Environmental Review Team Report

Mystic Woods
Stonington, Connecticut

ENVIRONMENTAL REVIEW TEAM REPORT
ON
MYSTIC WOODS CONDOMINIUM DEVELOPMENT
STONINGTON, CONNECTICUT

Watershed Areas

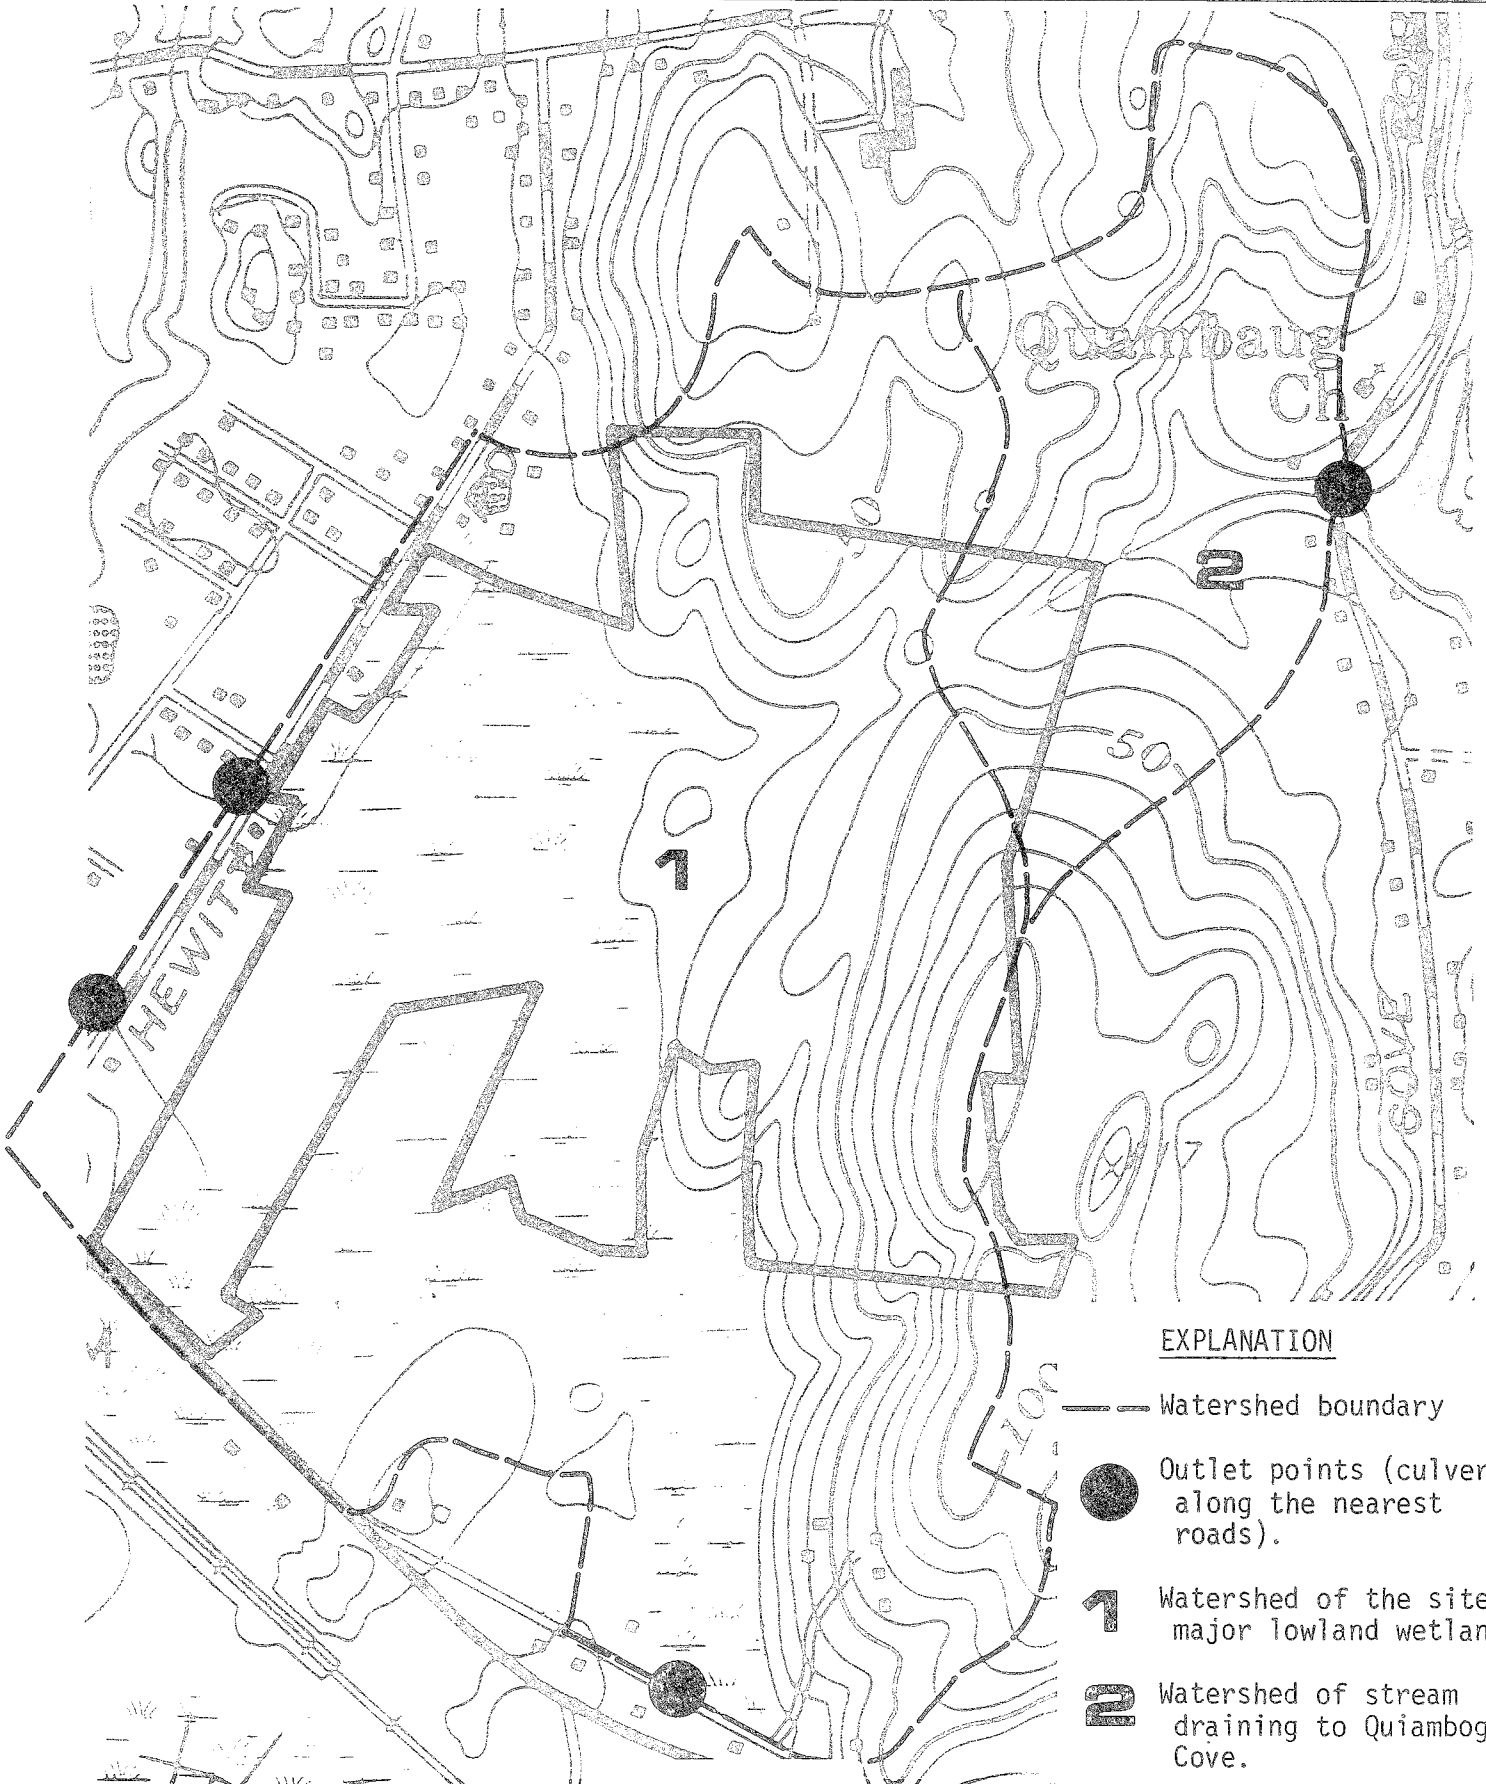
If the lowland wetlands are considered as a single entity, their watershed comprises approximately 250 acres. All but about 8 acres of the Mystic Woods property is included in the watershed. Only the eastern half of the site, consisting of approximately 50 acres, would be developed under the present plan, but the development would be intensive in that area. According to the developer's estimates, up to 35 percent of the developed area could be covered by impervious surfaces (roofs, pavement, etc.). The combination of impervious surfaces, soil disturbance and compaction, and loss of vegetation will cause runoff from the site to increase.

The table shows that substantial runoff increases may be expected from the area of intensive development. Since that area comprises about 20 percent of the lowland wetland's watershed, the peak flows in the outlet streams may be expected to experience significant increases on the whole. However, as suggested above, it is difficult to determine how the overall increases would be apportioned among the three streams.

Whether or not the runoff and peak-flow increases would create any flooding problems in the area depends upon the interplay of several factors, including sea level fluctuations and culvert sizes. Major coastal flooding would have a more widespread effect than stream flooding on land in the vicinity of the site. Runoff increases from Mystic Woods would not noticeably aggravate conditions during a coastal flood. However, if the outlet streams themselves can cause local flooding problems (i.e., in the absence of a coastal flood), then runoff increases from Mystic Woods could have detrimental effects. It would therefore be advisable to obtain a more complete study of the local surface hydrology, including an analysis of the culverts along the outlet streams from the site. Topics of discussion for the study are suggested below.

Resource Impact Matrix

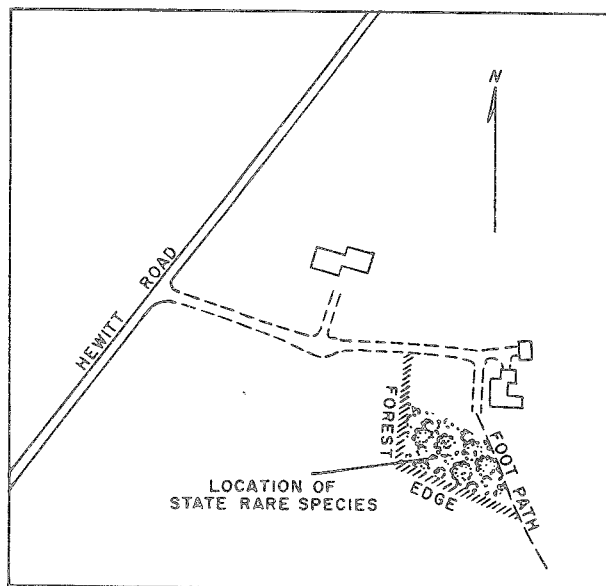
The central concern of this review is consistency with the policies for and potential adverse impacts to the freshwater wetlands and watercourses. Activities that could generate significant adverse impacts to this resource are (1) road construction, (2) alteration of the hydrologic characteristics of the wetlands, (3) sedimentation, and (4) stormwater damage and discharge. Each of these will be briefly discussed below:

- (1) Road Construction. Construction of the road network as proposed will culminate in the filling of nearly two acres of wetland representing about 7% of the freshwater wetlands located within the coastal boundary. The proposed main access road from Route 1 will account for 90% of this figure. This represents a direct and irreversible impact to the wetland below the road. These figures are based solely upon a width of 50' without any consideration for shoulders or lateral embankments. Furthermore, construction without any mitigation measures will result in sedimentation in the wetland and construction equipment operating outside the "road area," will impact additional wetland area.

- (2) Hydrologic Modifications. The main wetland area in the lowland is generally devoid of well defined drainage channels. Drainage is probably diffuse both as subsurface flow and surface or sheet flow. This complicates the evaluation of the impact of the road upon the wetland. In light of the length of road which traverses the wetland, especially if facilities for lateral drainage such as adequate sized culverts are not incorporated, the effect could be to significantly alter the hydrologic flow and thereby modify and change the existing biological characteristics and increase the flooding and flood frequency.

- (3) Sedimentation. Sediments, generated from upland site preparation and construction, if not controlled, could change the physical and biological character of the wetland. It could also change the flood elevation in the lowland area at least during design storms of short duration.

- (4) Stormwater Discharge. Release of stormwater without any retention from a project of this size has the capabilities to significantly alter the extent and duration of flooding, cause modifications to the biological characteristics of the wetlands, and degrade water quality through the introduction of sediments and chemicals derived from lawns, condominiums and especially paved areas.

Mitigation measures which could be incorporated into the project design so as to eliminate or minimize adverse impacts to the wetlands are:

- Elimination of the main access route from Route 1 and convert the "emergency road" to Hewitt Road into the primary traffic corridor. This would reduce direct wetland impacts by 90% and reduce the impacts resultant to changes in the hydrologic character of the lowlands. The following guidelines should be incorporated into the design and construction of the traffic corridor: (1) use the best available mitigation technologies to reduce controllable sedimentation, (2) locate the corridor so as to minimize the

encroachment on the wetland, (3) use low impact pile construction over wetlands and watercourses when feasible, and (4) avoid construction in the habitat of the state rare plant (discussed below).

- Prevent sediments, generated during site preparation and construction, from entering the wetland. This can be achieved through a combination of adequate natural buffers of soil and vegetation (should be widest in areas of steep slope) and haybale erosion controls, preferably two alternating rows of haybales.

- The stormwater system should be designed such that there is no increase in discharge from the site. This will necessitate a design based upon at least a 25-year storm and a stormwater retention system. Rather than replace the wetland which have some intrinsic capacity for stormwater retention, with a series of retention ponds, the ponds should be constructed on upland soils. This will minimize wetland impacts while providing the desired pond retention system. Moreover, there should exist an adequate number of catch basins which are cleaned regularly so as to prevent sedimentation into the wetland. The magnitude of nutrients and toxic chemicals entering the wetland and ultimately coastal waters could be an important concern given the magnitude of the project.
